Access Compliance Report Public Rights-of-Way (Curb Ramps)

Intersection ID: 10039591 Main Street: THORN_BLUFF_RD Cross Street: THORN_BLUFF_RD Location: W

ADA ID: 1EBC1772F1AE Ramp Type: Perp Initial Pass/Fail: Fail Overall Compliance: No Severity Score: 22.5

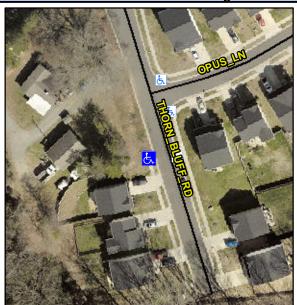
Not Found, R304.5.1, R304.2.2

Field Measurements/Component Compliance					
Compliance Description		Data	Comp	liance Description	Data
N/A	Ramp Length (in)	48.0	No	Ramp Slope (%)	8.9
No	Ramp Width (in)	47.0	Yes	Ramp XSlope (%)	2.1
N/A	Flare Type LT	N/A	N/A	Flare Type RT	N/A
N/A	Flare Slope LT (%)	N/A	N/A	Flare Slope RT (%)	N/A
N/A	Flare Traversable LT?	N/A	N/A	Flare Traversable RT?	N/A
N/A	Landing Length (in)	N/A	N/A	DWS Provided?	N/A
N/A	Landing Width (in)	N/A	N/A	DWS Contrast?	N/A
N/A	Landing Slope (%)	N/A	N/A	DWS Length (in)	N/A
N/A	Landing X Slope (%)	N/A	N/A	DWS Full Width?	N/A
N/A	Landing Curb? (Y/N)	N/A	N/A	DWS Offset (in)	N/A
N/A	Shared Landing?	N/A			
N/A	Gutter Ponding?	N/A	N/A	Gutter Slope (%)	N/A
N/A	Gutter Lip Ht (in)	N/A	N/A	Gutter X Slope (%)	N/A
N/A	Painted X Walk1?	No	N/A	Painted X Walk2?	N/A
	X Walk 1 Direction	То Е		X Walk 2 Direction	N/A
N/A	X Walk 1 Width (in)	N/A	N/A	X Walk 2 Width (in)	N/A
	X Walk 1 Slope (%)	2.5		X Walk 2 Slope (%)	N/A

Remove & Replace Entire Ramp.
